**Wonder Drive Subdivision
PRELIM PLAT PP2107-001**

REQUEST: Preliminary plat approval

DATE OF REVIEW: October 6, 2021

PRELIMINARY PLAT
OF
WONDER DRIVE SUBDIVISION

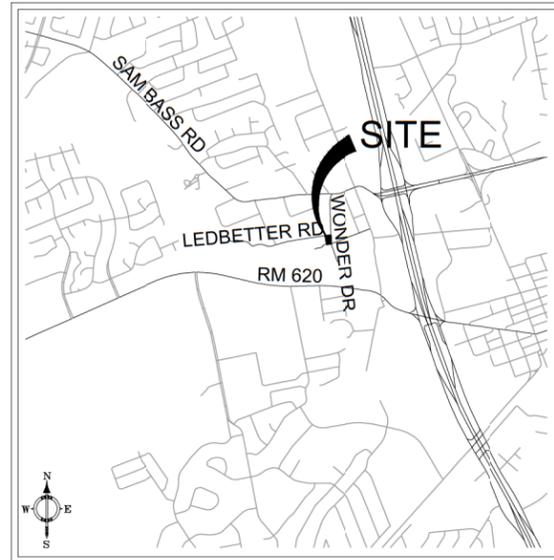
1. Include Lot 6, ROW, in the boundary line for the extent of the plat within the schematic.
2. Include all line types in the legend.
3. Include all lot and boundary line bearing and distance calls.

4. Add note, "No portion of this tract is encroached by the ultimate 1% annual chance floodplain."
5. Add "To be conveyed by deed to the City of Round Rock" within the lot 6 callout. Revise note 4 to reflect this language.

6. Provide relevant and descriptive benchmarks.
7. Provide chord bearing, length, and delta for the curve at Wonder Drive and Ledbetter Street.
8. Amend Note #4 to state "A ten-foot (10') PUE and sidewalk easement abutting and along the street side property line will be conveyed as depicted for all street side property lots shown hereon."

9. Provide standard building setback note.
10. Cover sheet: revise lots by type from "use residential" to Development".
11. Remove duplicate text and remove nonapplicable information from the cover page.

12. Correct cover page acreage.
